AMENDMENT XII

The replacement pages in the enclosed packets are to be inserted in the CRBRP Environmental Report as follows:

Additional Information for Detailed  
Environmental Assessment of the Clinch  
River Breeder Reactor Plant (CRBRP) Site

<u>Section</u>	<u>Major Reason for Revision</u>
3.8 -	Update fuel shipping information
5.3 -	Update fuel shipping information and revise dose estimates due to material in transit.
5.7 -	Revised to expand and update the discussion of the fuel cycle.
13.0 -	Revised to incorporate a reference to Section 5.3.

FIGURE 5.7-2

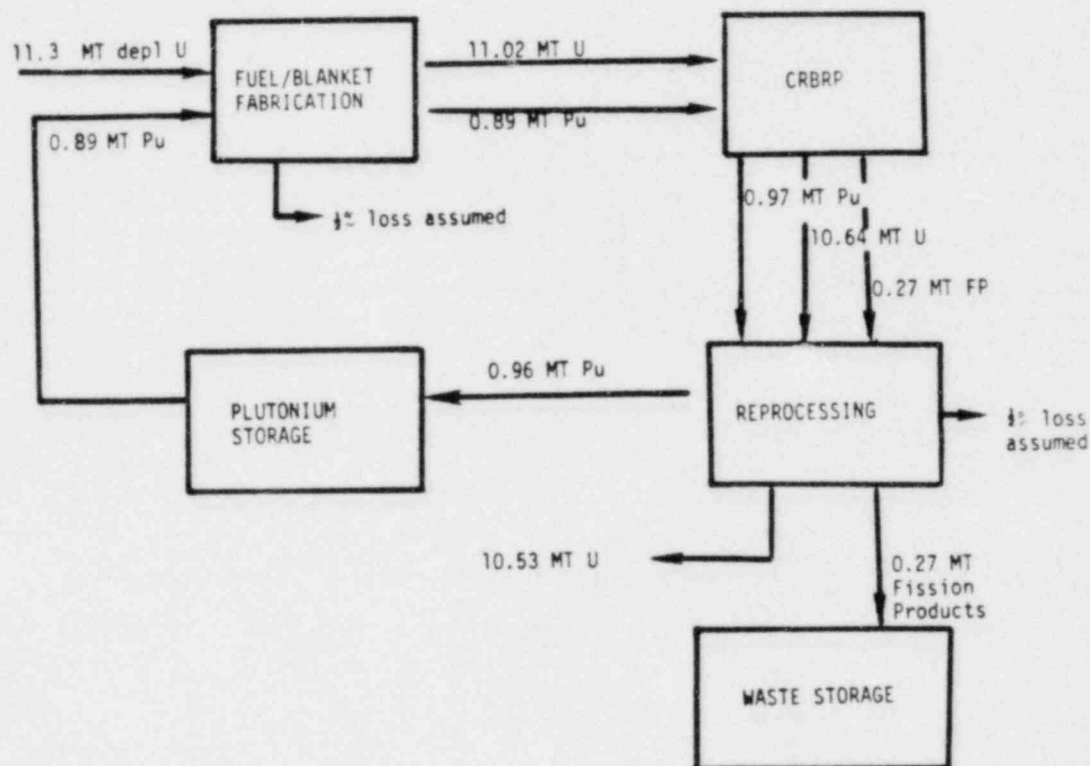
A simplified schematic diagram of the CRBRP fuel cycle employing plutonium recycle is shown in Figure 5.7-2. The mass flow parameters are characteristic of those for the CRBRP under psuedo-average equilibrium-cycle conditions (where the cycle-to-cycle variations in the batch CRBRP fuel management have been averaged out). At equilibrium, approximately 0.9 MT of plutonium and 11 MT of depleted uranium are fabricated into mixed-oxide fuel and blanket assemblies per year. One half of one percent heavy metal has been assumed to be lost in the fabrication process. In the reactor core, irradiation at 975 MW(th) for 274 equivalent full power days destroys approximately .28 MT of plutonium and 0.38 MT of uranium per year through fission and nuclear transmutation reactions. 0.27 MT of fission product isotopes are produced per year. Because of the breeding
